Reference: Hanford Waste Vitrification Plant
DOE Contract DE-AC06-86RL10838
Fluor Contract 8457

NUMBER	REV	DATE	TITLE
DCN - #0128	0	10/26/93	CHANGE FWX AND RWX VALVE AND FIRE HYDRANT NUMBER DESIGNATIONS AND INCORPORATE WHC A160 MECHANICAL SITE UTILITIES REV. 6 COMMENTS. "APPROVED FOR CONSTRUCTION"

FLUOR DANIEL US DEPARTMENT OF ENERGY HANFORD WASTE VITRIFICATION PLANT DESIGN CHANGE NOTICE	DCN - 0128	REV 0	PAGE 1 OF
	DCN TITLE Change FWX and RWX valve and fire hydrant number designations and incorporate WHC A160 Mechanical Site Utilities Rev. 6 comments.		DATE INITIATED
			10/12/93
			PACKAGE NO. CWBS-A160

A. Valve Number Changes

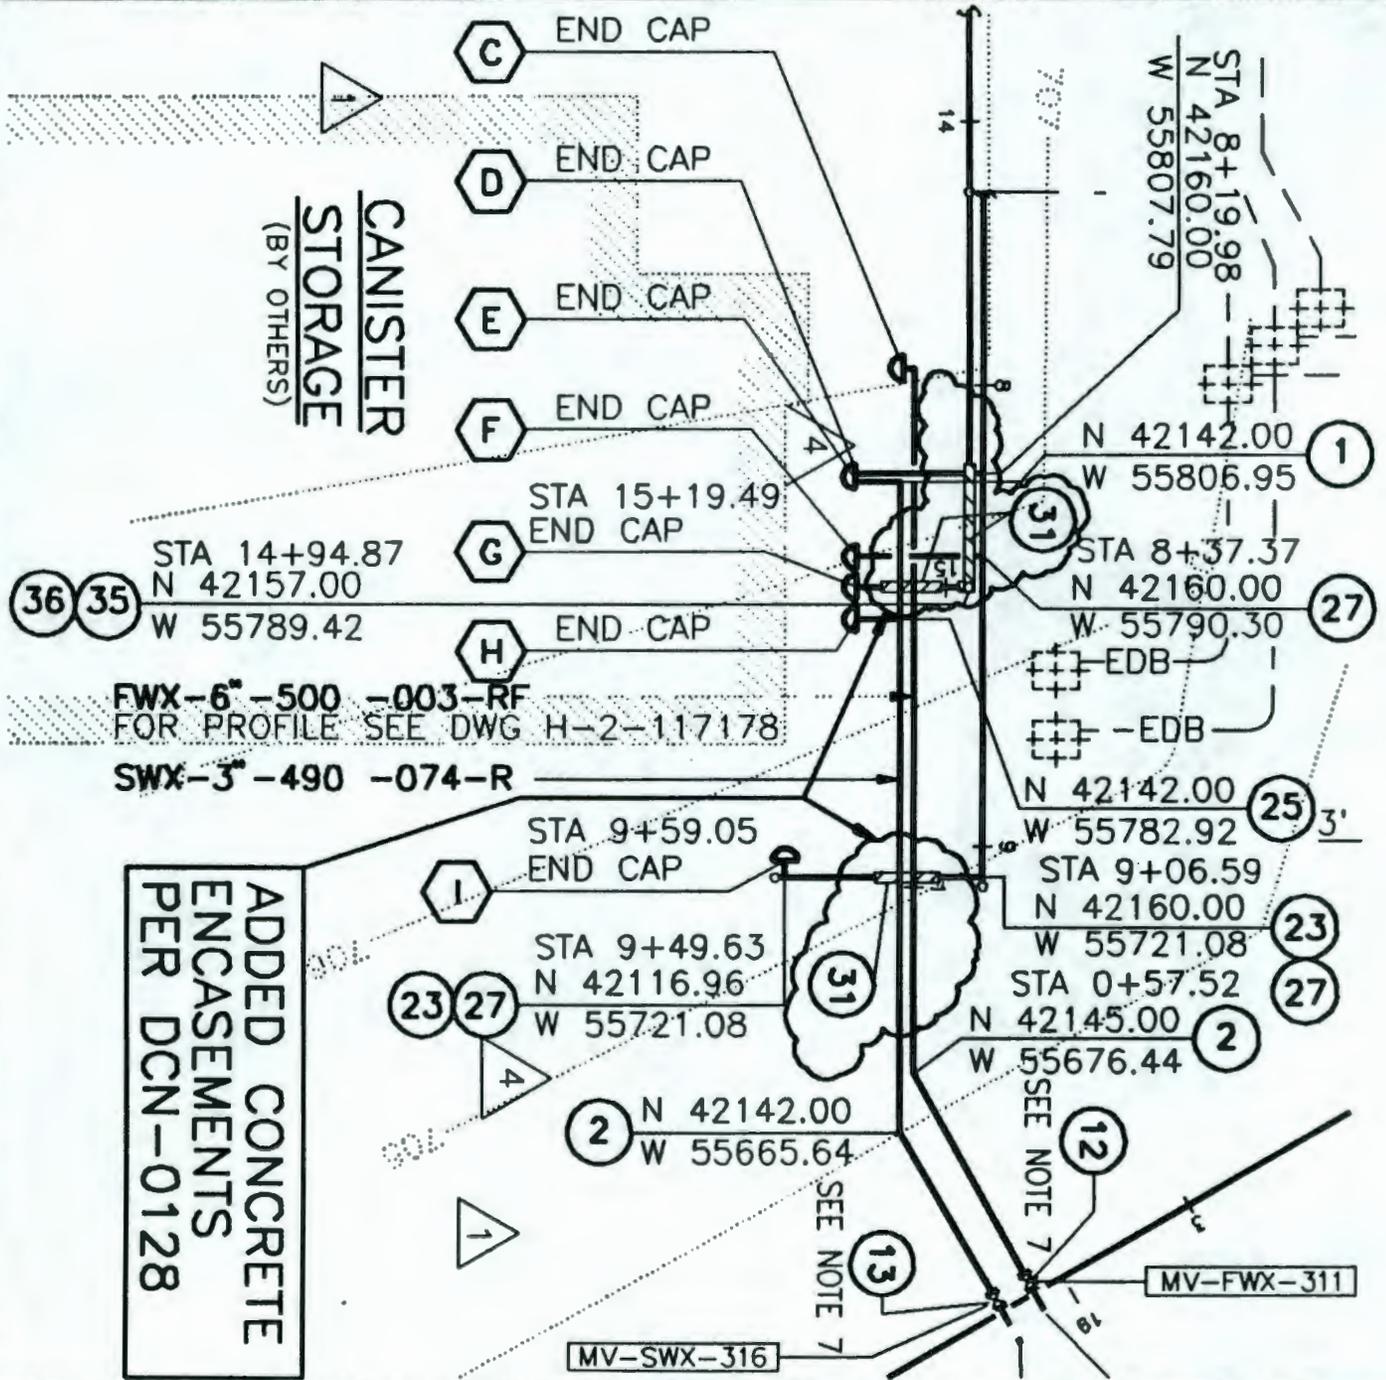
DRAWING NO.	ZONE	OLD VALVE/ HYDRANT NUMBER	NEW VALVE/ HYDRANT NUMBER
H-2-117152	A5	MV-FWX-072	MV-FWX-099
H-2-117152	A7	MV-RWX-074	MV-RWX-031
H-2-117152	A7	MV-RWX-052	MV-RWX-013
H-2-117154	B3	MV-FWX-121	MV-FWX-131
H-2-117154	B5	MV-FWX-161	MV-FWX-171
H-2-117154	C5	MV-FWX-141	MV-FWX-151
H-2-117154	C5	MV-FWX-113	MV-FWX-168
H-2-117154	C6	MV-FWX-171	MV-FWX-181
H-2-117154	D6	HY-FWX-114	HY-FWX-118
H-2-117154	C6	MV-FWX-114	MV-FWX-188
H-2-117154	C6	HY-FWX-115	HY-FWX-189
H-2-117154	C6	MV-FWX-115	MV-FWX-189
H-2-117154	B3	MV-FWX-112	MV-FWX-129
H-2-117154	F4	MV-FWX-082	MV-FWX-092
H-2-117154	F4	HY-FWX-082	HY-FWX-092
H-2-117159*	B3	MV-RWX-010	MV-SWX-010

*WHC Comment 12

BASE DOC. NO. H-2-117156
SHT./PG. 1 REV. 4
CR NO. CR-HWVP-0917R1

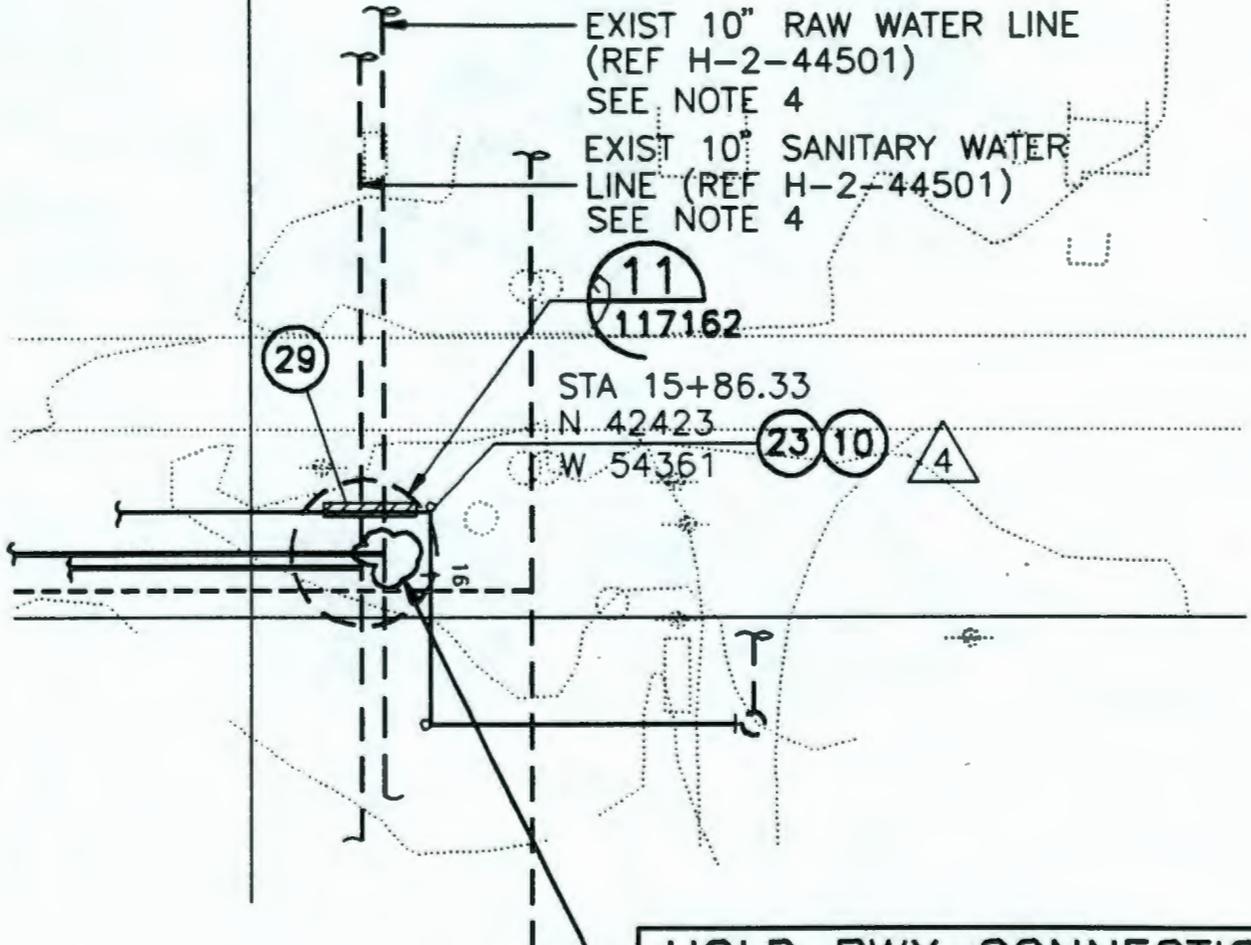
DESCRIPTION OF CHANGE:
CONSTRUCT CONCRETE ENCASEMENTS PER "WHC COMMENT NO. 8"

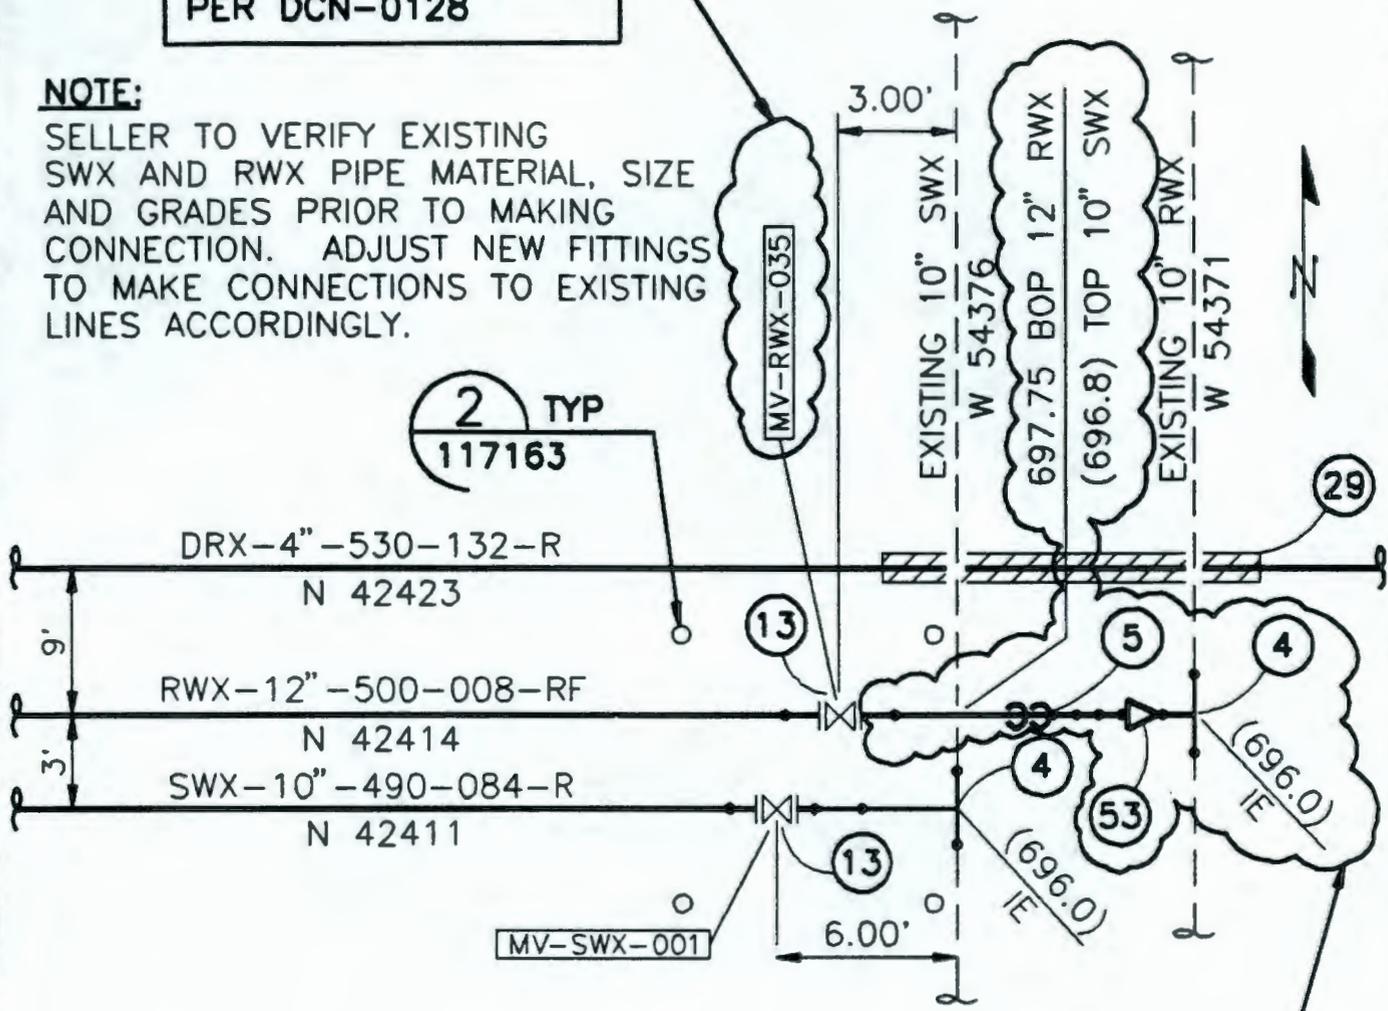
**UPDATE VALVE NUMBER
PER DCN-0128**

HOLD (HWVP-FD-433) CONSTRUCTION OF RWX-12"-500-008-RF BETWEEN FACE OF FLANGE (MV-RWX-035) & CONNECTION TO EXISTING B-PLANT 10" RWX LINE PER DCN-0128

FLUOR DANIEL		U.S. DEPARTMENT OF ENERGY HANFORD WASTE VITRIFICATION PLANT		DESIGN CHANGE NOTICE	
DESCRIPTION OF CHANGE: HOLD RWX CONNECTION TO EXISTING B-PLANT 10" RWX LINE PER "WHC COMMENT NO. 13"				BASE DOC. NO. H-2-117162 SHT/PG. 1 REV. 2 CR NO. CR-HWVP-0917R1 DISCIPLINE: CIVIL CADFILE: B117162A	
PREPARED BY: L. BERRY	DATE: 10-20-93	DCN - 0128		REV. 0	PAGE 6
DISCIPLINE ENGINEER: <i>Bernard R. Ciambini</i>	DATE: 10/20/93

SELLER TO VERIFY EXISTING SWX AND RWX PIPE MATERIAL, SIZE AND GRADES PRIOR TO MAKING CONNECTION. ADJUST NEW FITTINGS TO MAKE CONNECTIONS TO EXISTING LINES ACCORDINGLY.
